ADDENDUM

Project:	Bear Creek Fire Station	Addendum # 02
Owner:	Onslow County	
Owner ID No.:	Bid No. 102-25C	
DKA Project No.:	2324	
Prepared By:	Alexandre Penegre	
Bid Documents Issue Date:		4/22/2025

C6 PLAN DETAIL - LOUVER JAMB @ CMU/METAL PANEL
3" = 1'-0"

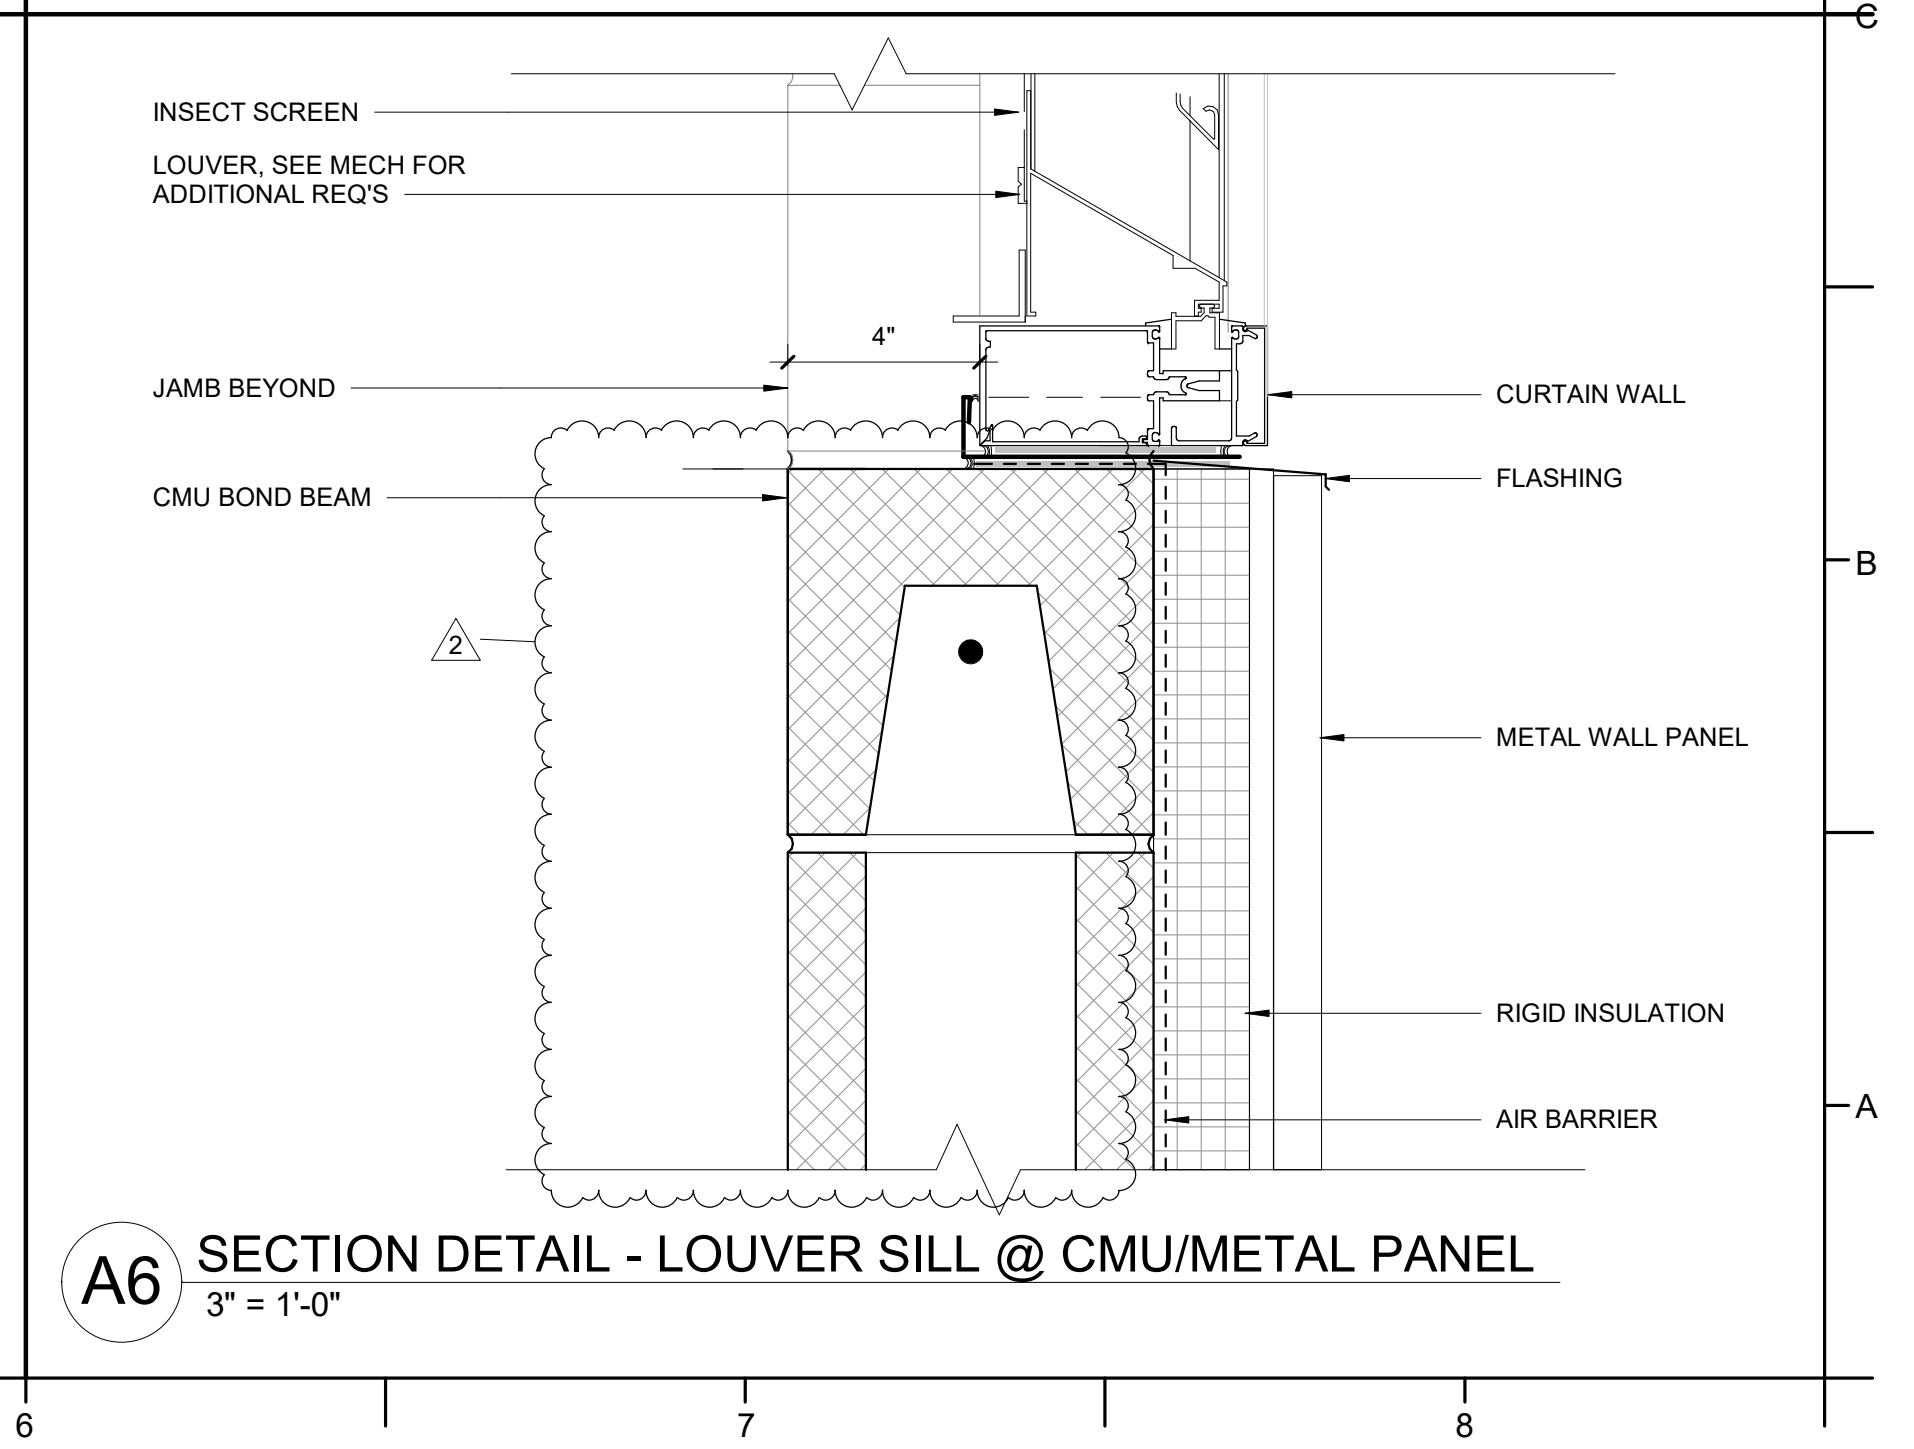
- b. Details F6, C6, A6 revised to show 8" CMU in lieu of 12" CMU addressed in Addendum O1.
 - c. Details F1 and C1 revised to add 2 ½" and 8" metal studs.

C1 TYPICAL CONCRETE WALL OPENING DETAILS
NTS

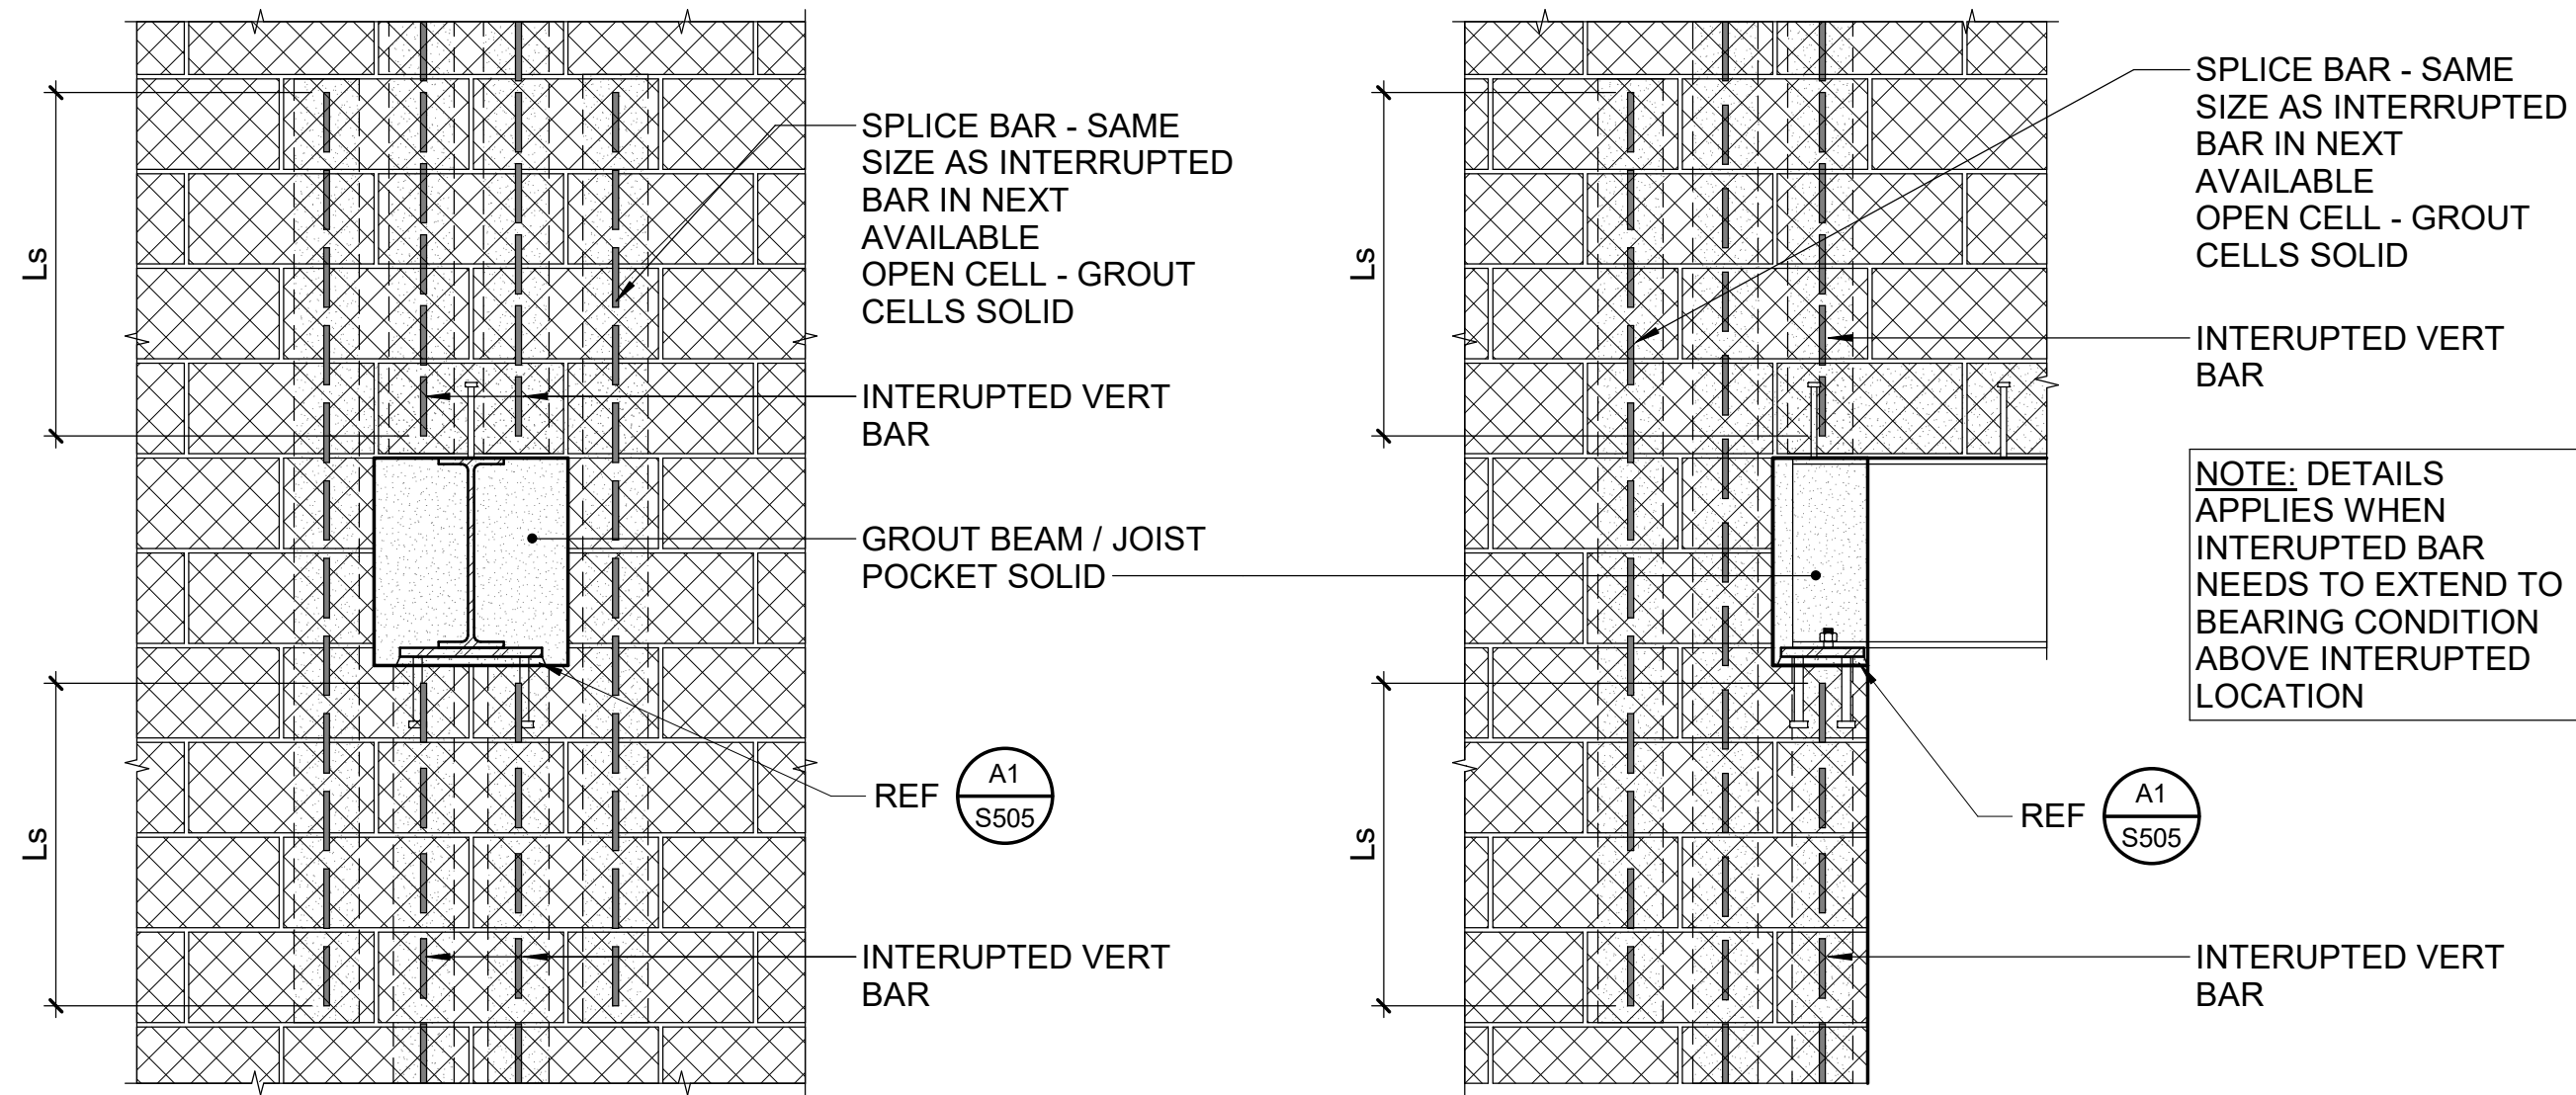
- 38. Drawing S505
 - a. Added detail C1, "TYPICAL CONCRETE WALL OPENING DETAILS"
- 39. Drawing P100
 - a. Revised waste oil piping to avoid conflicts with grade beams.
